AMERICAN SUZUKI MOTOR CORPORATION

08V-249
(17 pages)

**SAFETY RECALL CAMPAIGN #2A05
CERTAIN 2008 GSX1300RK8 MOTORCYCLES
IGNITION SWITCH INSPECTION/REPLACEMENT**

RE: GSX1300RK8 Ignition switch lead wire routing inspection recall Campaign

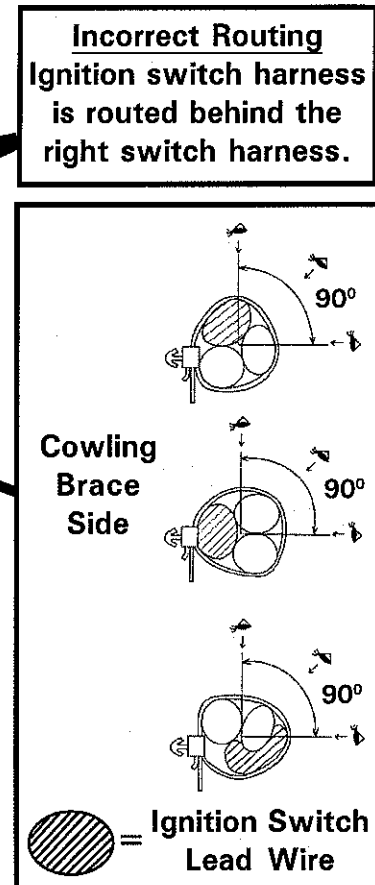
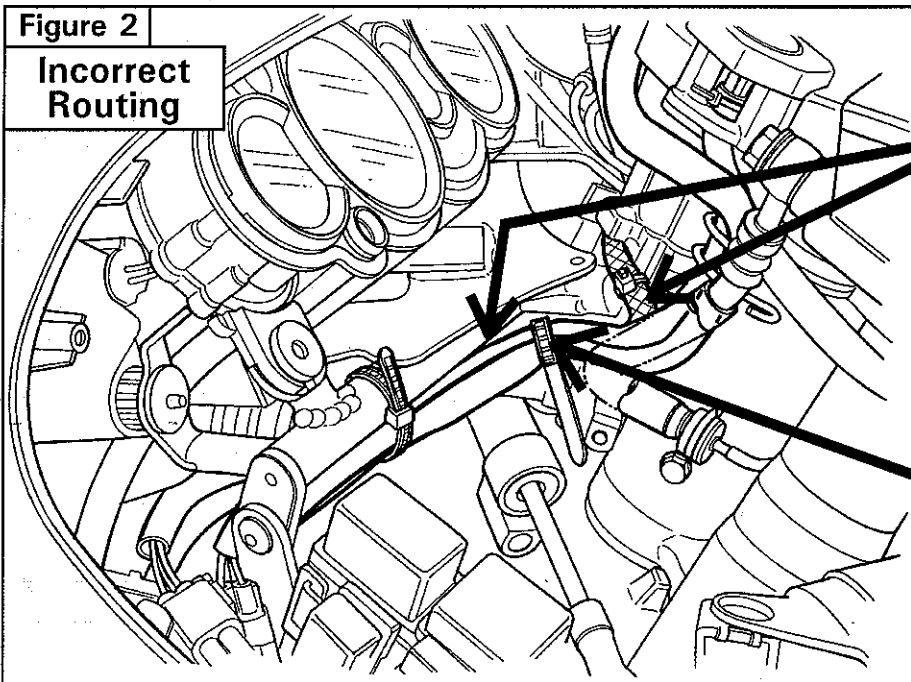
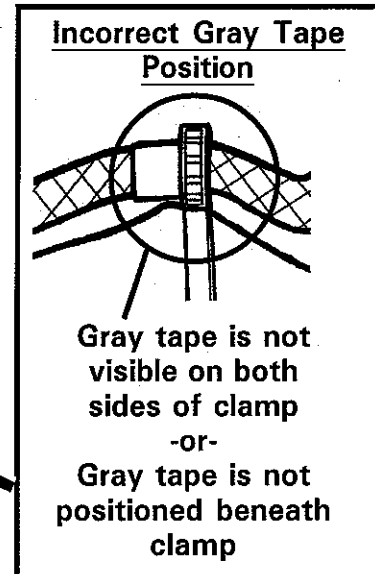
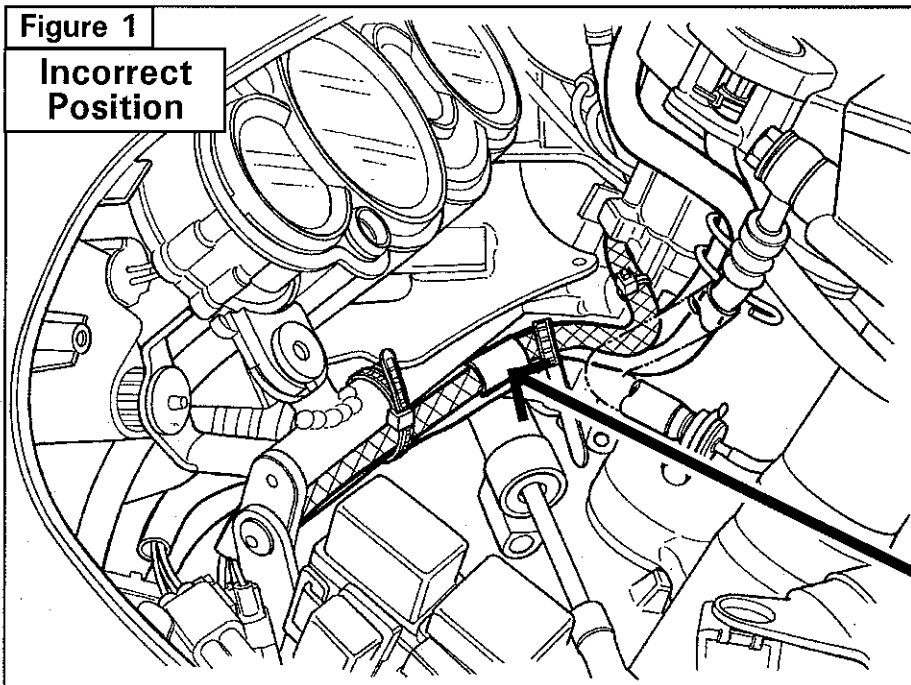
1. Remove the upper and lower meter panels (refer to Service Manual page 9D-15).
2. Check if the ignition switch lead wire is clamped and routed correctly. Incorrect positions are shown in Figures 1 and 2. Correct routing and clamping is shown in Figures 3 and 4 on page 5.

1. Reroute the ignition switch lead wire correctly (Figure 3 and Figure 4). The ignition switch lead wire should not be covered by the other wire harnesses.
2. Turn the handlebars back and forth to verify that the steering operates smoothly and the wiring harness does not become kinked or pinched.
3. Proceed to PUNCH MARK AT VIN on page 8.

Figure 3

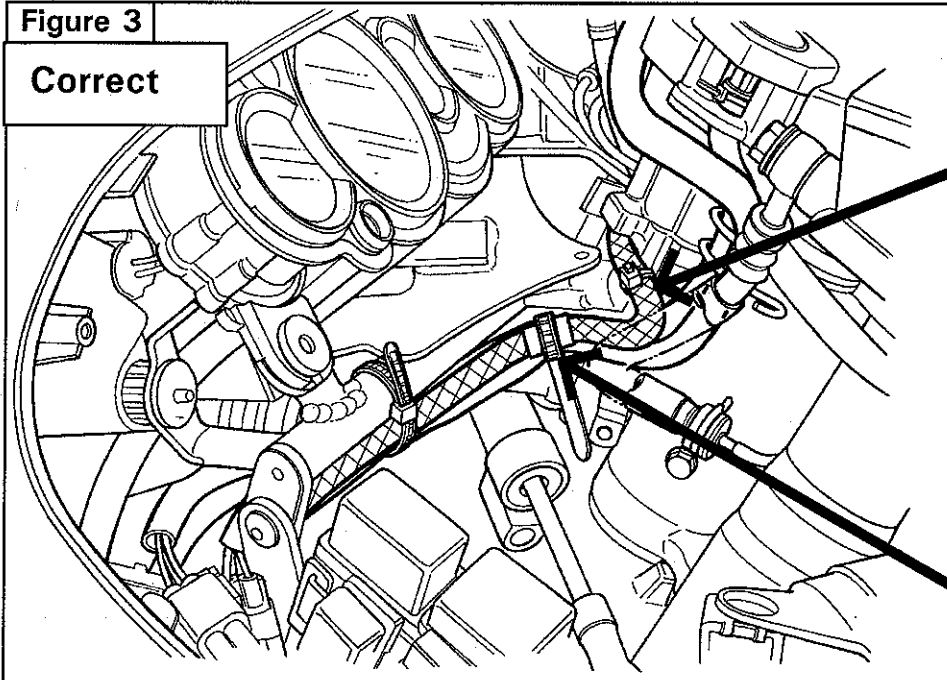
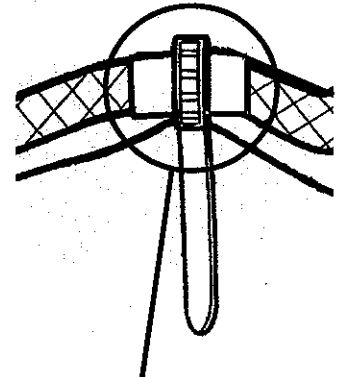
Correct Routing
The ignition switch lead wire is routed in front of the right switch lead wire.

Gray tape is visible on both sides of clamp.
